West Wratting Parish Council

Response to the request for comments on the Scoping Environmental Impact Assessment (EIA) Report for Kingsway Solar

Figure 3. The boundary of West Wrattling Parish (blue) and the solar farm areas A, B, C (dark gray) superimposed on the landscape character map (figure 4.1) from the Greater Cambridge Shared Partnership’s Landscape Character Assessment¹.

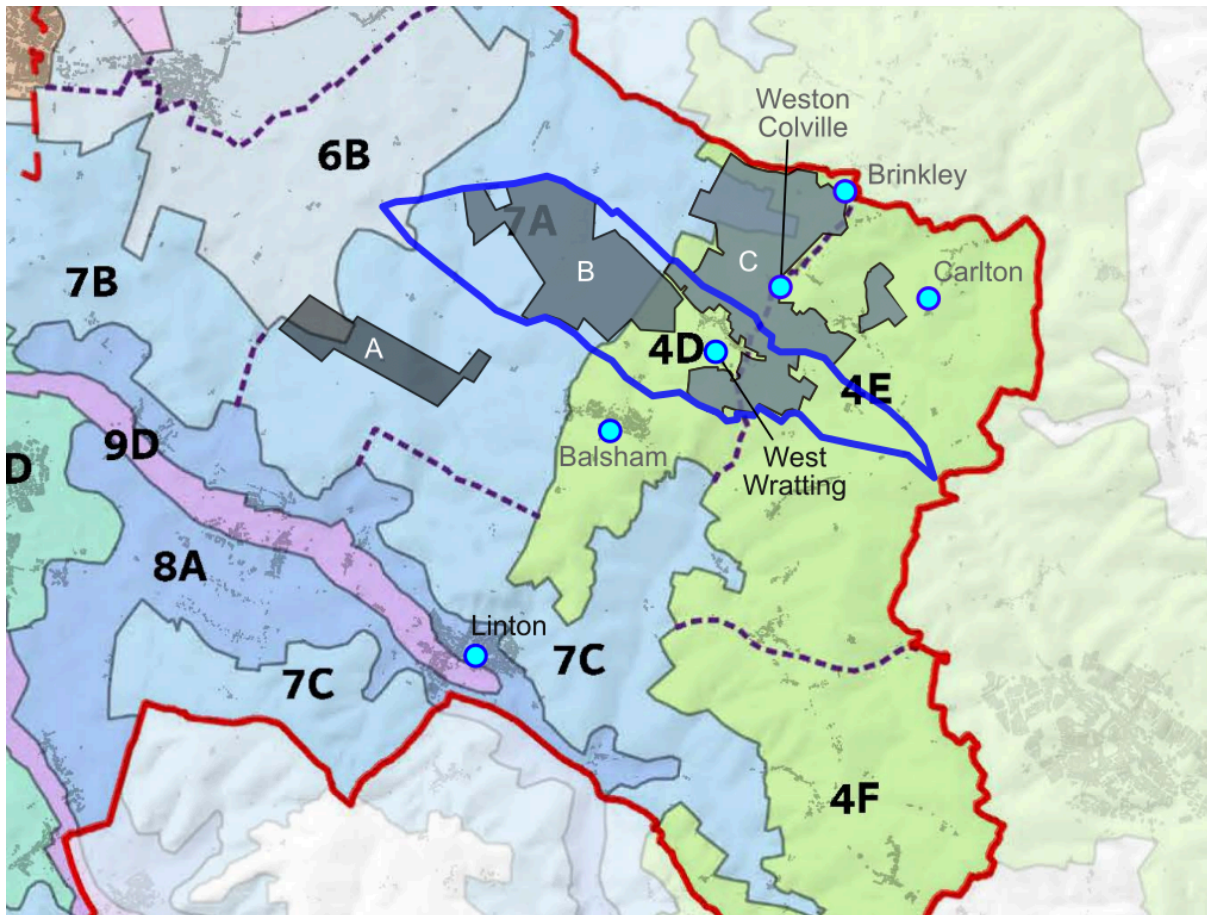
As described elsewhere in the scoping EIA report and shown clearly in [figure 3](#) area C is a distinctly different landscape character to areas A and B (being wooded clayland rather than chalk hills), so the ecology and habitats are likely to be different. This is definitely apparent to those of us who live here. Moreover, the relevant waterbodies for area C are different from those of areas A and B³³.

Figure 4. Listed buildings in and around area C (blue). Grade II buildings are shown in green and grade II* in yellow. It is similar to figure I10 in the scoping EIA report.

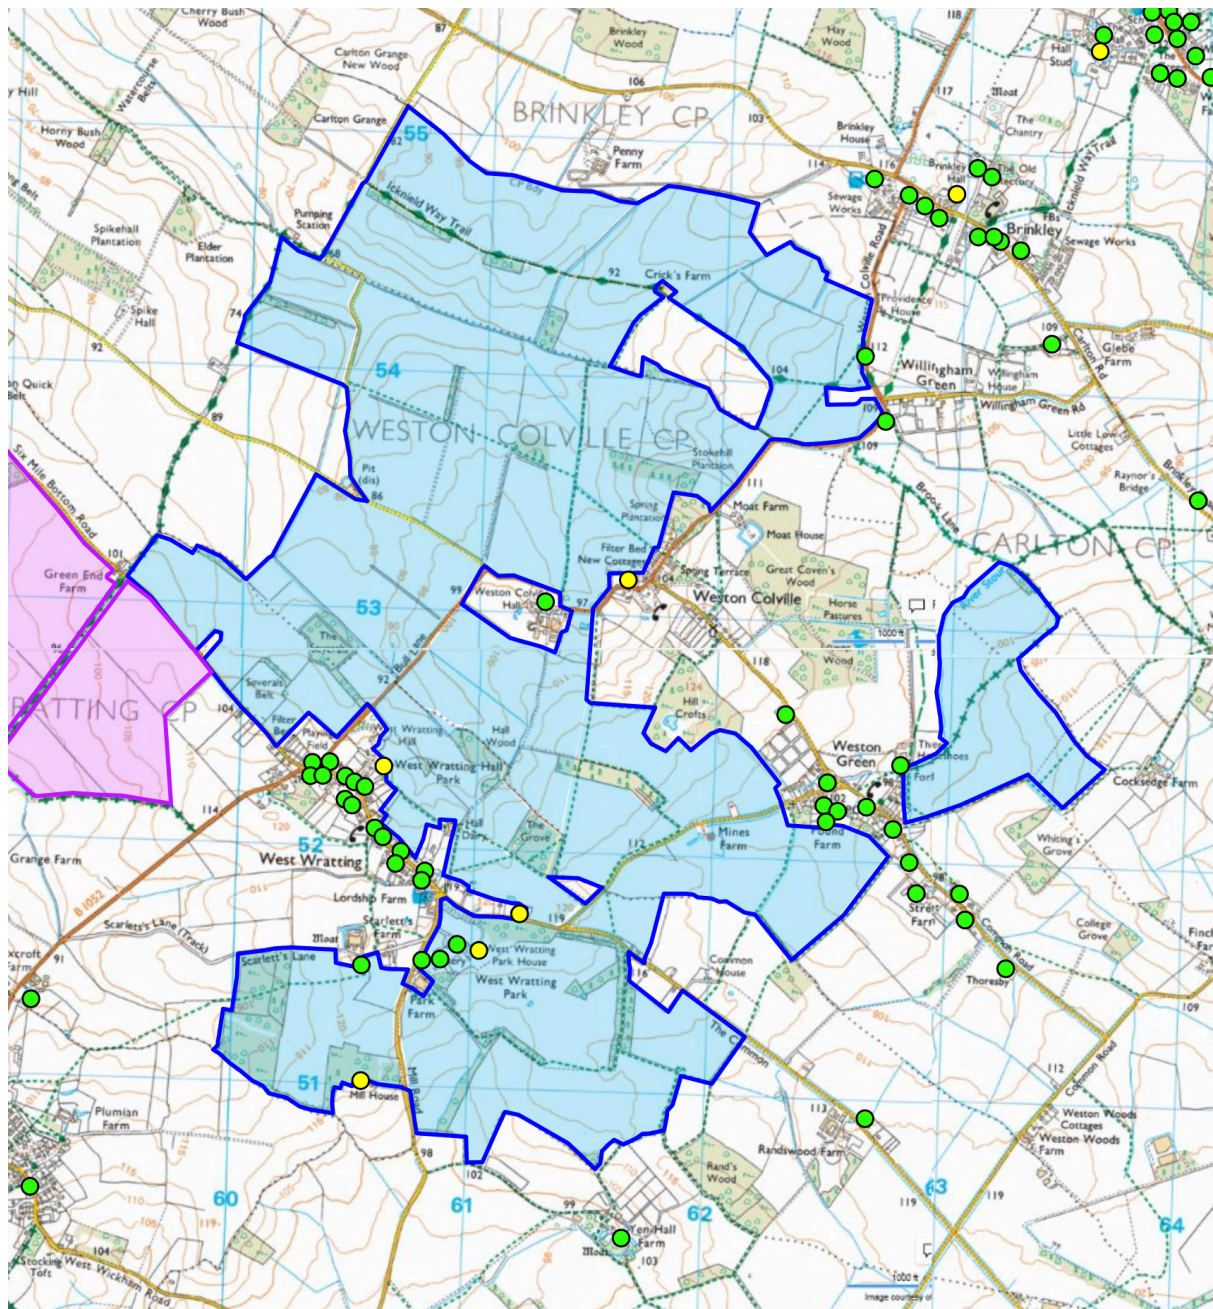
Paragraph 2.4.24 of the scoping EIA report incorrectly says “*there are no listed buildings within the developable areas*”²¹. In fact, although there are no listed buildings in areas A and B there are three listed buildings that are well inside area C including a grade II* early 19th century manor house that is in a designed landscape setting.

There are several other listed buildings right on the boundary of development area C, including four of grade II*.

One area of particular concern is that surrounding the West Wrating Parish Church of St Andrew, which is a Grade II* listed building. Putting solar panels in the fields surrounding this would very significantly impact on the heritage value of this building, since the panels would be very visible. It would materially alter the atmosphere of tranquillity that the building currently possesses. Further, the churchyard is regularly used for community events

Similarly, the settings of the churches at West Wratting and Weston Colville and of Concordia house - which are all right on the boundary of area C - must not be visually compromised by nearby solar farm infrastructure. The text of section 6.3 does not make clear the potential level of change to the setting of these assets. Section 6.8.5 says that both churches are located approximately 20 m from Area C but figure 10 shows their churchyards are immediately adjacent to the scheme boundary.

Figure A1. Important viewpoints in the development areas. Grade II buildings are shown by green circles and grade II* by yellow. Ickneild way and Fleam Dyke are shown by green lines.

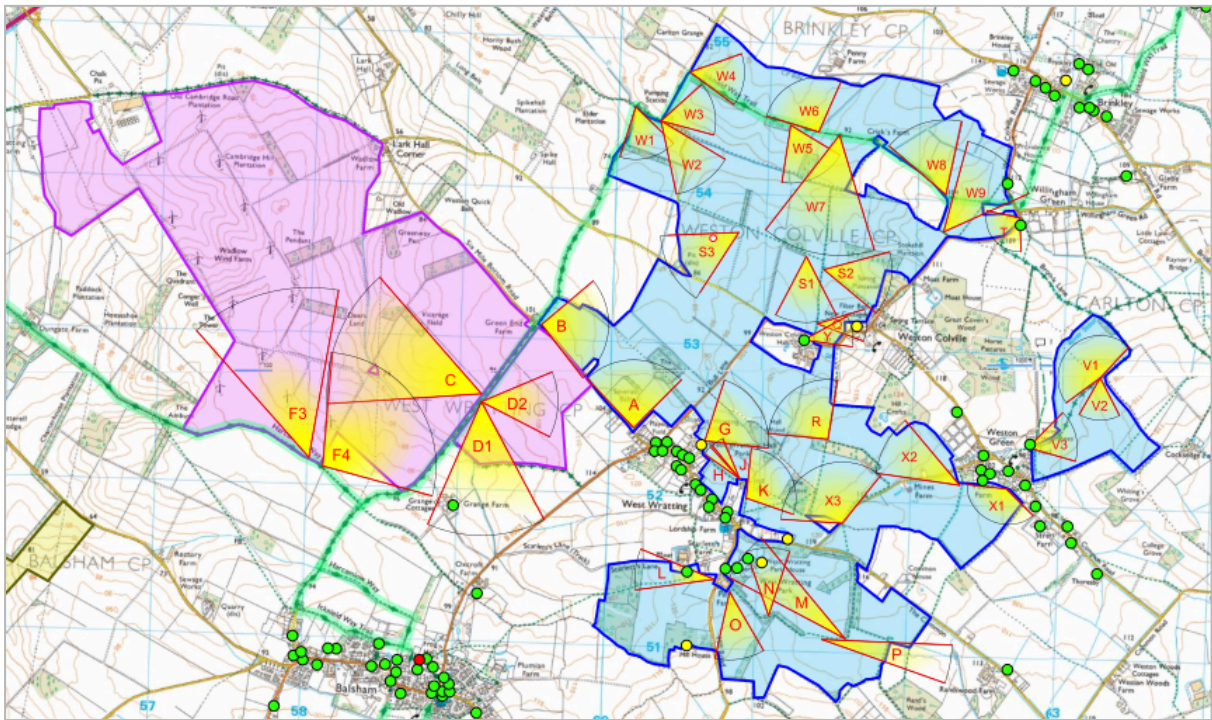
Suggested viewpoints of and from heritage assets are shown in [Appendix A](#) which includes links to photographs from those viewpoints. These assets include views of the landscape from along the linear features of the Icknield Way, Fleam Dyke, Harcamlow Way and the Roman Road. It will be important to use views that will show the significance and extent of changes to the settings of the Grade II* listed buildings that are inside or on the boundary of area C. This includes land inside the scheme that is immediately adjacent to the churches at West Wrating and Weston Colville, and the large area of land to the South East of the West Wrating Park House, which was a designed parkland setting for this early 19th century manor house.
